Planning & Zoning Commission Staff Report

Meeting Date: September 6th, 2023

Description: **Manors at Lynstone Park (Lynstone Park View, LLC) Preliminary Plat** – A request for a Preliminary Plat to construct a 9-lot single family home development on property zoned R-6 District

Figure 4. Development Retaining Wall

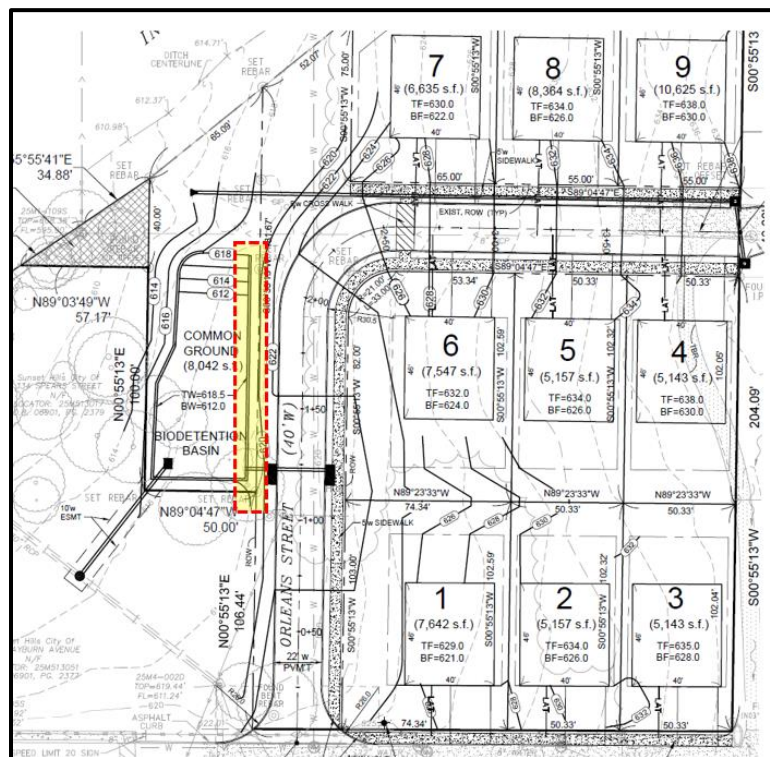
As previously stated, the applicant is proposing common ground with a bio-retention basin west of the proposed roadway and east of Lynstone Park. A retention basin is a man-made reservoir that captures and holds rainwater. They are designed to slow the flow of runoff so water can be stored for use during drier periods, or it may also provide treatment by storing polluted storm water until natural processes remove contaminants. The retention basin depicts walls

surrounding the basin. The wall is depicted at 6.5' in height. It should be noted that the City does not permit new public roads that require the support of a private retaining wall. If the project moves forward into the subsequent required plans (Improvement Plans and Record Plat), the City will continue to review the wall to ensure that the proposed public road does not require the support of the private retaining wall.
